Access Compliance Report

Public Rights-of-Way

(Curb Ramps)

Intersection ID: 13283	Main Street: SOUTHWOOD_AV	Cross Street: W_SUMMIT_AV	Location: W
ADA ID: F53D9B9EA559	Ramp Type: BlendTrans2	Initial Pass/Fail: Fail	Overall Compliance: No
Severity Score: 18.75			
Codes/Mitigation Info/Possible Solution		Field Measurements/Component Compliance

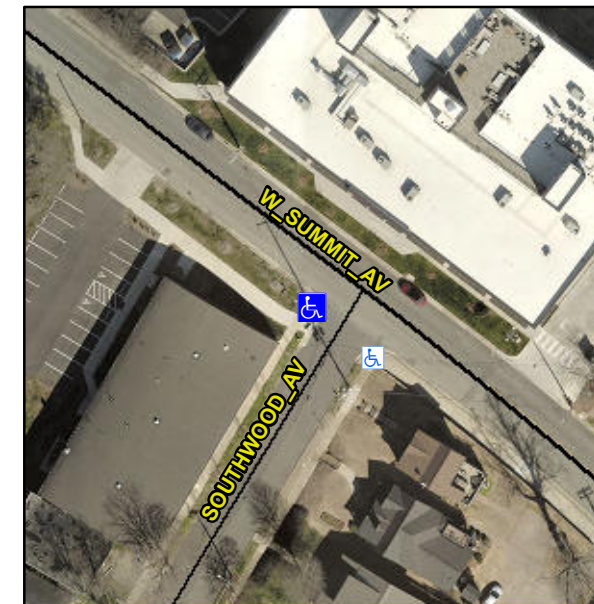
Not Found, R304.5.1, R304.5.3

Compliance	Description	Data	Compliance	Description	Data
N/A	Ramp Length (in)	112.0	Yes	BlendTrans Slope (%)	1.1
No	Ramp Width (in)	32.0	No	BlendTrans XSlope (%)	3.3
N/A	Flare Type LT	N/A	N/A	Flare Type RT	N/A
N/A	Flare Slope LT (%)	N/A	N/A	Flare Slope RT (%)	N/A
N/A	Flare Traversable LT?	N/A	N/A	Flare Traversable RT?	N/A
N/A	Landing Length (in)	N/A	N/A	DWS Provided?	N/A
N/A	Landing Width (in)	N/A	N/A	DWS Contrast?	N/A
N/A	Landing Slope (%)	N/A	N/A	DWS Length (in)	N/A
N/A	Landing X Slope (%)	N/A	N/A	DWS Full Width?	N/A
N/A	Landing Curb? (Y/N)	N/A	N/A	DWS Offset (in)	N/A
N/A	Shared Landing?	N/A			
N/A	Gutter Ponding?	N/A	N/A	Gutter Slope (%)	N/A
N/A	Gutter Lip Ht (in)	N/A	N/A	Gutter X Slope (%)	N/A
N/A	Painted X Walk1?	No	N/A	Painted X Walk2?	No
	X Walk 1 Direction	To NE		X Walk 2 Direction	To SE
	X Walk 1 Width (in)	N/A		X Walk 2 Width (in)	N/A
	X Walk 1 Slope (%)	6.7		X Walk 2 Slope (%)	2.7
	X Walk 1 X Slope (%)	2.8		X Walk 2 X Slope (%)	8.5

N/A	Ramp inside XWalk1?	N/A	N/A	Ramp inside XWalk2?	N/A
	Road Slope (%)	1.3		Clear Space?	N/A
	Road X Slope (%)	6.8	N/A	Clear Space to XWalk (in)	N/A
N/A	Any Obstructions?	N/A	N/A	Storm Grate/Utility Hazard?	N/A
	Obstruction Type			Storm Grate/Utility Type	
		N/A			N/A
			Yes	Surface Condition? (G/P)	Good
			No	Curb Slope (%)	22.8

Remove & Replace Curb Ramp With Two New Directional Ramps or Equivalent.
